DS-K1T341A Series MinMoe Terminal Release Notes (2022-09-30)

Device Model: DS-K1T341AM DS-K1T341AMF Naming Rule: M for M1 card, F for fingerprint	Firmware Version	ARM: ACS_641_AI3_EN_STD_V3.2.30_build220913 ACS_641_AI3_EN_NEU_V3.2.30_build220913
	Software Version	HikCentral AC: https://www.hikvision.com/en/support/download/software/hikcentral-access-control-v1-3-0/ iVMS: https://www.hikvision.com/en/support/download/software/ivms4200-series/

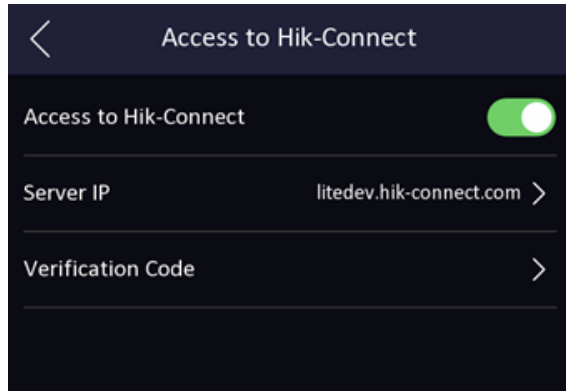
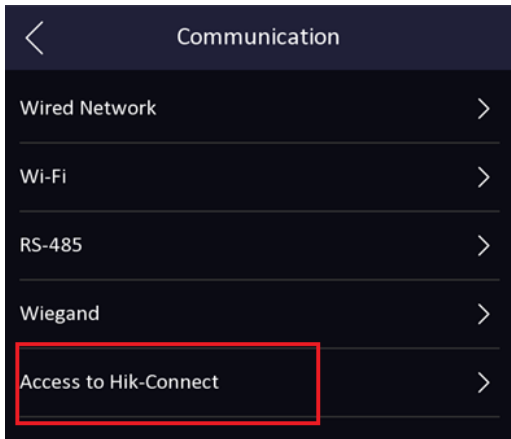
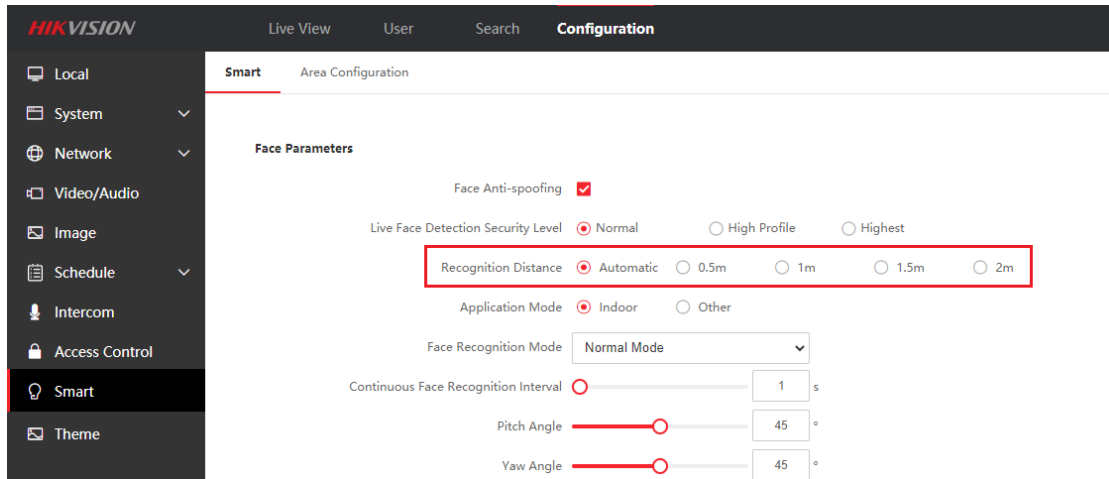
1. Add Hik-Connect menu in device UI Menu → Comm. The function is disabled in default.
